Rezoning Transportation Analysis

Petition Number: #2021-256

General Location Identifier: 04913101, 04907101, 04906101, 04903208

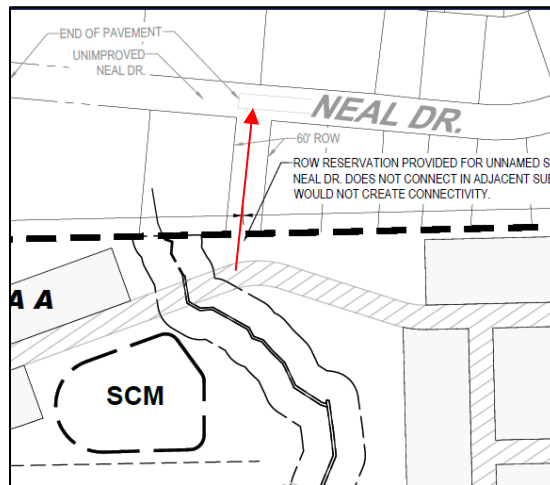
4. ~~Revise site plan to commit to construct an 8-foot planting strip, and 5-foot sidewalk on all proposed public streets per Chapter 19 / Chapter 20 of City Code. The site plan shall label and dimension both items from the back of curb and gutter.~~
